MINERALS PROGRAM INSPECTION REPORT PHONE: (303) 866-3567

MINE NAME:	MINE/PROSPECTING ID#:	MINERAL:	COUNTY:
Weimer Ranches #4 Mine	M-2021-045	Sand and gravel	Montrose
INSPECTION TYPE:	WEATHER: Clear	INSP. DATE:	INSP. TIME:
Monitoring		February 6, 2025	12:00
OPERATOR:	OPERATOR REPRESENTATIVE:	TYPE OF OPERATION:	
Weimer Ranches, LLLP	None	110c - Construction Limited Impact	
REASON FOR INSPECTION:	BOND CALCULATION TYPE:	BOND AMOUNT:	
Normal I&E Program	None	\$33,105.00	
DATE OF COMPLAINT:	POST INSP. CONTACTS:	JOINT INSP. AGENCY:	
NA	None	None	
INSPECTOR(S):	INSPECTOR'S SIGNATURE:	SIGNATURE DATE:	
Dustin Czapla		February 6, 2025	
-	Q-

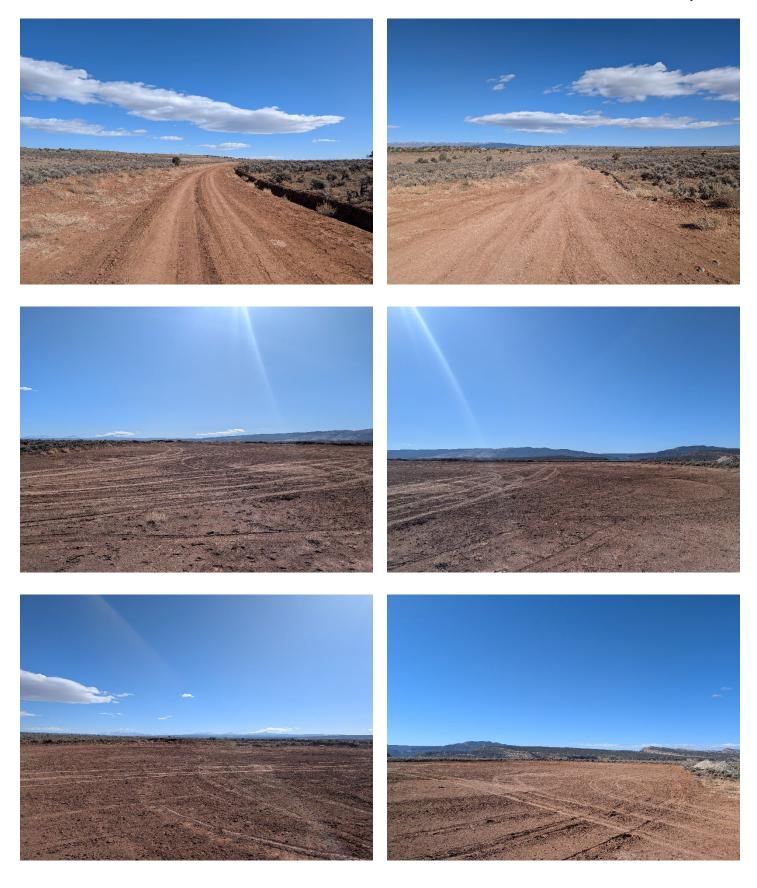
Adequate mine identification signage was not noted at the entrance to the site. This has been noted as a problem on page one of this report.

Operations are just beginning at this site. The access road has been constructed. The road was in good shape, with no ruts or rilling observed. Approximately two acres are currently disturbed in the pit area, where vegetation has been cleared in preparation for topsoil removal. It didn't appear that any gravel had been extracted yet. No stockpiles or equipment were observed on site.

CORRECTIVE ACTIONS: The operator shall, at the entrance of the mine site, post a sign which shall be clearly visible from the access road with the following: the name of the operator, a statement that a reclamation permit for the operation has been issued by the Colorado Mined Land Reclamation Board; and the permit number. The operator shall submit photo documentation that a proper sign has been posted by the corrective action date.
